Re: King I Mine, C-1981-035

Stoner Engineering: Quarterly Inspection: Water Quality Improvements

Re: King Coal I – Quarterly Water Quality Improvements Inspection

Pic. 2 – Sediment gage in east pond.

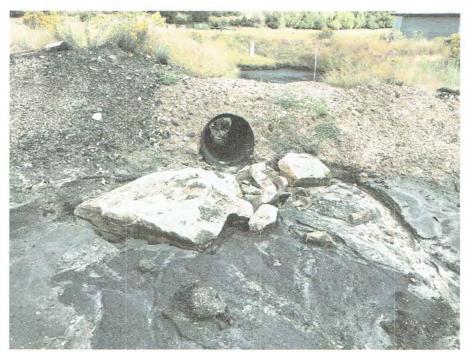
Both ponds were generally dry at the time of the inspection (see Pic. 1). The ponds both appeared to generally be in good condition and while there is additional sediment in the ponds, the sedimentation gages show the ponds are not yet it need of cleaning (see Pic. 2). The ponds should continue to be monitored after storm events to ensure that excess sediment does not reduce the required storage capacity available for storm water runoff.
